**RESPONSE TO BRISBANE CITY COUNCIL INFORMATION REQUEST: S.13 OF THE  
DEVELOPMENT ASSESSMENT RULES**

**DEVELOPMENT PERMIT FOR MATERIAL CHANGE OF USE FOR MULTIPLE DWELLING OVER  
LAND AT 63 – 69 MELTON ROAD, NUNDAH (LOT 2 ON RP121656 & LOT 19 – 20 ON RP33945).**

**COUNCIL REFERENCE: A006988485**

**Figure 1: Streetscape Surveillance Opportunities.**

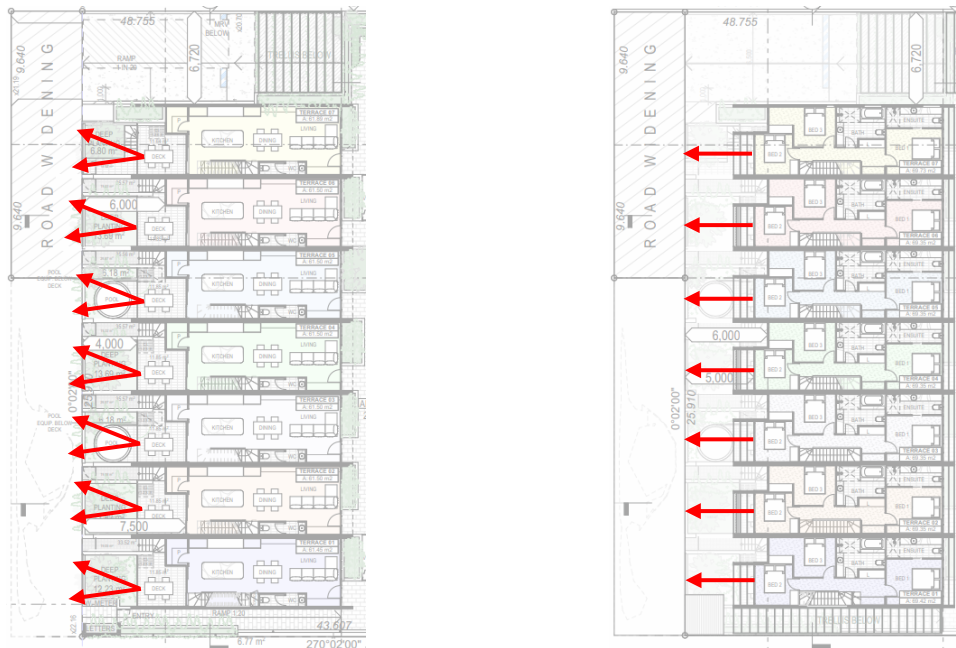
*The development is seeking a performance outcome for some aspects regarding the building envelope – namely, reduced minor boundary setbacks and marginal building height noncompliance.*

*The front setback is measuring at 5m to wall and 3.5m to blade walls and deviates from the acceptable setback of 6m to wall. Some minor non-compliance of side boundaries is also noted not meeting AO3 and AO6 of the Multiple dwelling code.*

a. *Amend the proposal plans to achieve compliance with AO3, AO6 of the Multiple dwelling code.*

- The proposed development provides an inviting and engaging streetscape that defines the street edge. The proposal incorporates habitable spaces via private open space and communal open space that is orientated towards to Melton Road frontage, offering formal and informal casual surveillance opportunities. Refer to **Figure 1** below.

- As outlined in **Figure 1** above, the proposed development delivers casual surveillance opportunities through habitable balconies and windows orientated towards Melton Road.

**Figure 7:** Revised internal communal open space.

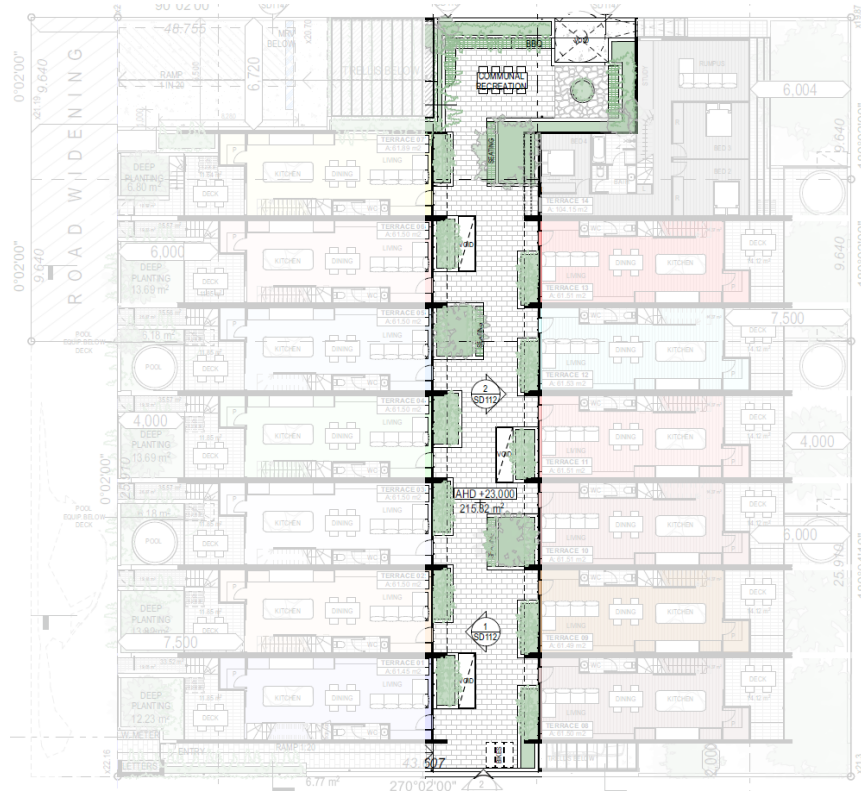
*The separation between the terrace blocks is about 6m, which is less than the required 12m between habitable rooms as required by AO3(d) of the Multiple dwelling code. Ground floor planting lacks detail on species for effective privacy screening, and upper levels do not specify adequate screening. Suggest for landscaping input for further review of plant species and appropriateness.*

- Provide further details on planting specifications to ensure visual privacy and address residential amenity concerns related to overlooking in accordance with PO3 of the Multiple dwelling code.*

- Where habitable windows along the ground level are visible from the internal pedestrian pathway, landscaping and outdoor seating is proposed to visually buffer habitable spaces. The proposed planters will accommodate a variety of shade tolerant screening trees, shrubs and groundcovers that can suitably screen the habitable windows. Refer to **Figure 7** below.

- In addition to the proposed landscaping, the windows have been deliberately offset from neighbouring habitable windows, minimising overlooking and limiting views into neighbouring properties. Refer to **Figure 7** below.

**Figure 8:** Revised communal open space area (location of outdoor seating outlined in red).

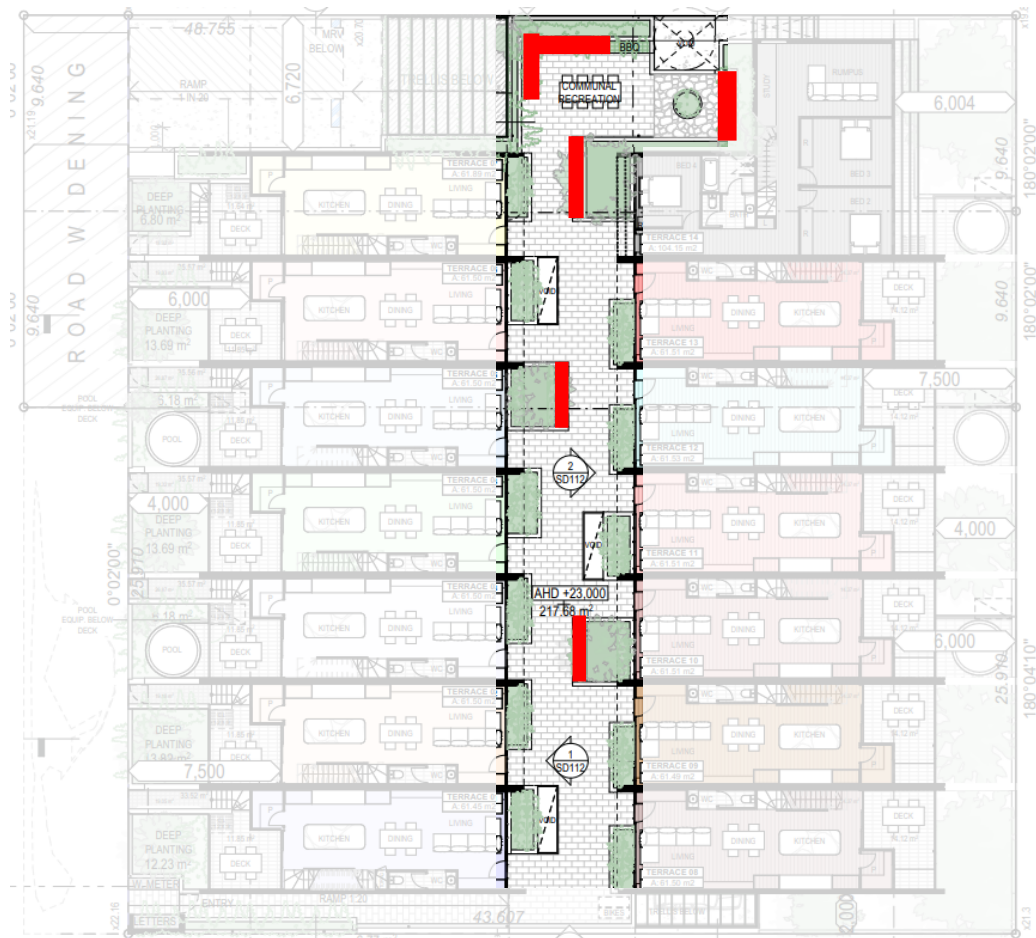
The communal open space currently totals around 45m<sup>2</sup> with a BBQ area to the north the rest is passive space between two terrace blocks. This does not meet AO30.1b of the Multiple dwelling code requirements, as the usable space falls short of 5% of the site area in one or two consolidated areas (with at least one over 100sqm).

- a. Provide amended design and details to communal open space to comply with PO30 of the Multiple dwelling code, potentially by enhancing the internal pedestrian laneway with benches and planters, while maintaining residents' privacy and amenity. Alternatively, revise the design to meet AO30.1 the Multiple dwelling code requirements.

As demonstrated within the Revised Architectural Plans (**Attachment B**), the proposed internal pedestrian laneway has incorporated additional seating areas and a revised landscaping outcome, consistent with Council's request. The revised landscaping outcome provides increased planter depths, ensuring that landscaping can positively contribute to the communal open space area whilst delivering privacy and amenity for residents. **Figure 8** below indicates the revised communal open space design.

Consequential to the revised design, the proposed development accommodates a total 304.67m<sup>2</sup> (15.48% of the site area) of communal open space, complying with Acceptable Outcome **AO30.1** of the Multiple Dwelling Code.

**Figure 9:** Revised refuse storage area.

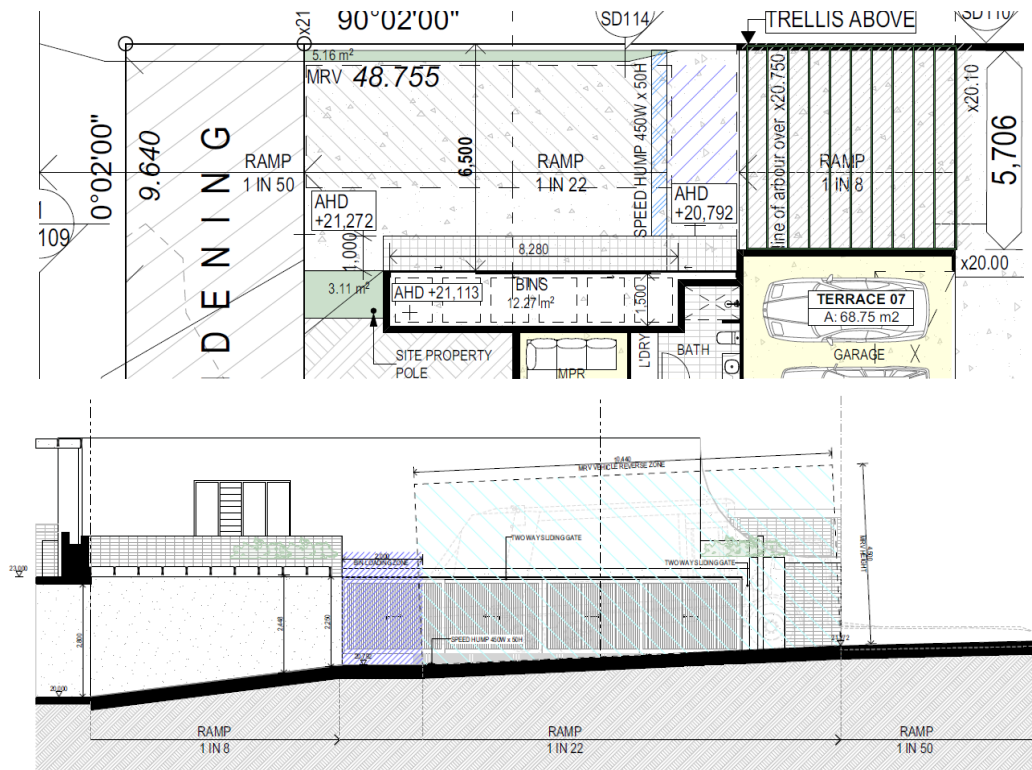
*Although the proposed refuse collection and storage area appears sufficient in size to accommodate the required bins, several aspects remain unclear: the roofing and complete screening of the area have not been confirmed, access points are unspecified, and residents would be required to dispose of refuse from within the aisle. Additionally, the enclosure's dimensions have not been indicated. In accordance with PO32/AO32 of the Multiple dwelling code and PO8/AO8.1 & AO8.2 of the Infrastructure design code, address the following requirements:*

- a. *Submit revised architectural plans that clearly show a refuse storage area situated either within a building (as a room) or as an enclosure (roofed and fully screened), with a minimum area of 12m<sup>2</sup> (internal dimensions of 8m x 1.5m). Label the amended plans as 'Roofed and wholly screened refuse enclosure.'*
- b. *Using the revised plans, specify the intended access points and illustrate how residents will be able to access each bin individually. Confirm that residents can safely access and dispose of refuse without having to stand in the aisle.*
- c. *Clearly indicate both the area (m<sup>2</sup>) and internal dimensions.*

- **Item 9(a)** – As outlined in **Figure 9** below, the proposed refuse area provides an area of 12.27m<sup>2</sup> and is roofed and wholly screened.
- **Item 9(b)** – Please refer to the Revised Waste Management Plan included in **Attachment E** for further detail.
- **Item 9(c)** – The plans have been amended to include the internal dimensions and area (m<sup>2</sup>) of the refuse storage area. Refer to the Revised Architectural Plans included in **Attachment B** for further detail.

Figure 10: Revised Waste / Servicing arrangements

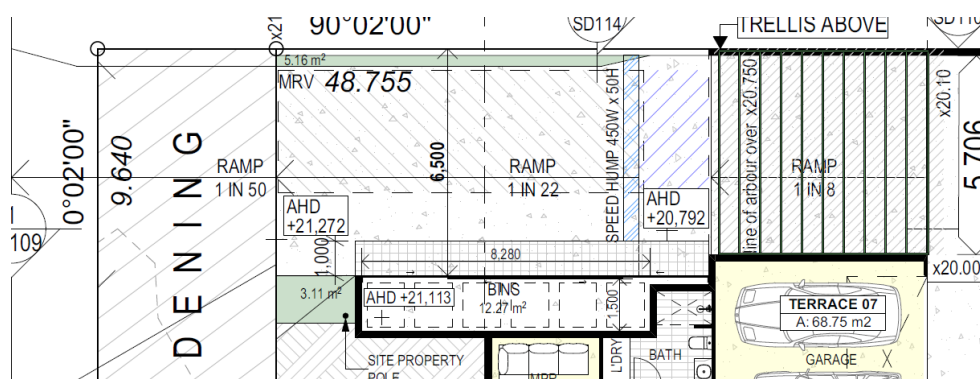
It is noted the crossover and two-way aisle trafficked by the Refuse Collection Vehicle (RCV) is 5.7m wide in lieu of the required 6.5m, the RPEQ certified swept path analysis has utilised a steering angle of 40.0 in lieu of the required kerb-to-kerb turning radius of 9.757m and shows a dual front axle vehicle. Also, a speed bump is required on the gradient change at the rear of the RCV to prevent bins rolling down the ramp. In accordance with PO19/AO19.2, AO19.3 of the Transport, access, parking and servicing code and PO8/AO8.1 & AO8.2 of the Infrastructure design code, provide the following:

- Provide amended architectural plans which demonstrate the crossover and two-way aisle have a minimum width of 6.5m.
- Utilising amended plans, provide an RPEQ certified swept path analysis for a RCV (as per BSD-3008-2) which demonstrates safe and efficient on-site servicing whilst utilising a kerb to-kerb turning radius of 9.757m. Ensure the kerb-to-kerb turning radius is included in the vehicle specification legend.
- Demonstrate on amended plans a speed bump at the gradient change from the 1:50 to the 1:10.

- **Item 10(a) & 10(b)** – Refer to the Revised Traffic Assessment included in Attachment D for further detail.
- **Item 10(c)** – The plans have been amended to show a speed bump at the gradient change from 1:50 to the 1:10. Refer to **Figure 10** below for further detail.
